ADDENDUM NO. 1

- A. Date: 6 June 2012
- B. From: Bahr, Vermeer and Haecker Architects, Ltd.
- C. To: Prospective Bidders.
- D. Project: Lexington Public Schools
Bryan Elementary School Addition & Renovation
Bid Packages No. 2 thru No. 6
Lexington, Nebraska
- E. This addendum is issued by the Architect to all bidders of record prior to receipt of proposals. Bidders shall acknowledge receipt of this addendum by so indicating on the Bid Form. Failure to do so may subject Bidder to disqualification.
- F. All information and instructions given herein shall become a part of the Contract Documents.
- G. This Addendum contains four (4) total page with four (4) attachment.

DETAILS

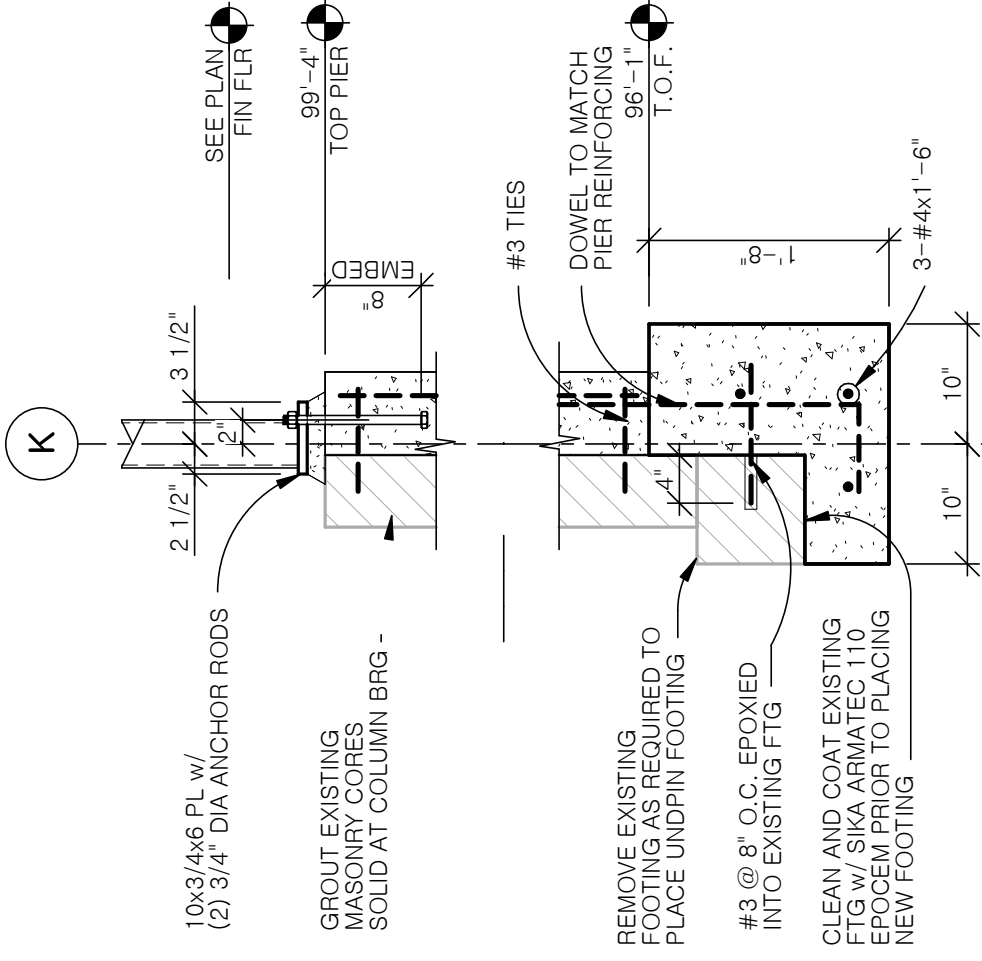
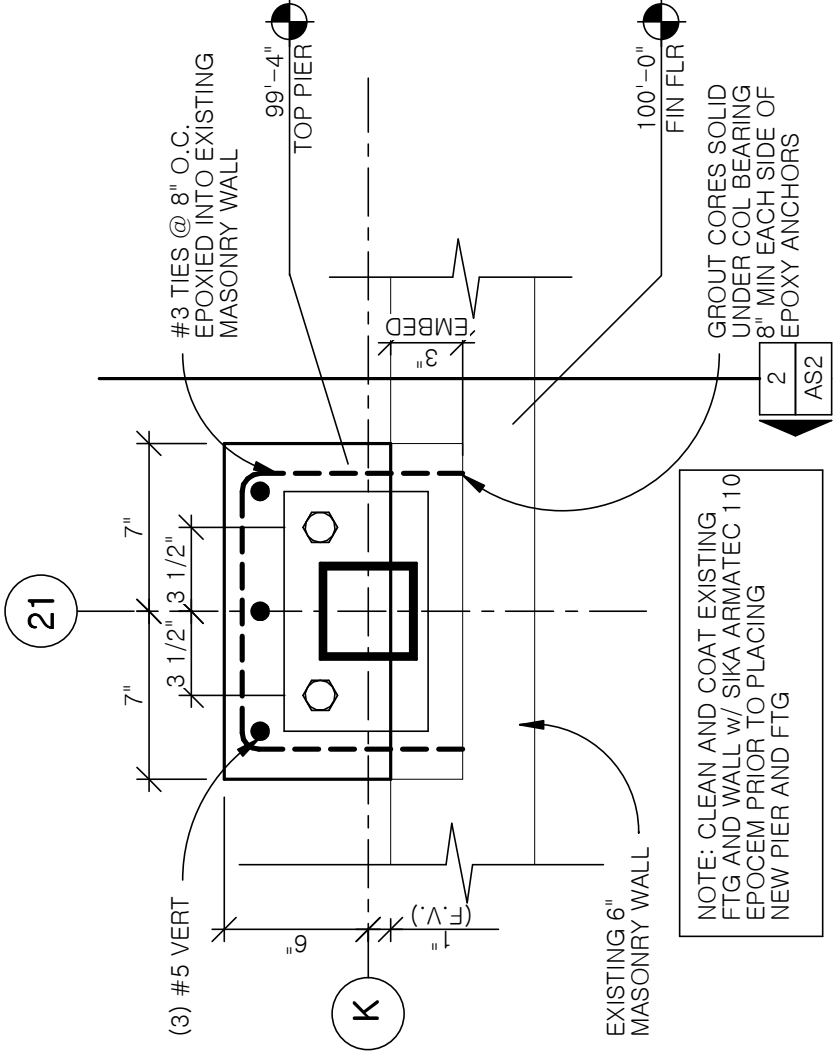
2. Reference Attachment 'AS1'; see Attachment 'AS2' for new foundation details for the revisions to foundation plan in Area B.
- B. Sheet S2.00 – GENERAL NOTES AND TYPICAL DETAILS
1. Reference Drawings A6 and A10; delete the note 'INSUL – SEE ARCH' and replace with the following:
 - a. "2 INCH THICK EXTRUDED POLYSTYRENE BOARD INSULATION, DOW CHEMICAL STYROFOAM SCORE BOARD OR APPROVED EQUAL, EXTEND 2'-0" DOWN VERTICALLY AND 2'-0" HORIZONTALLY UNDER THE INTERIOR CONC. SLAB"
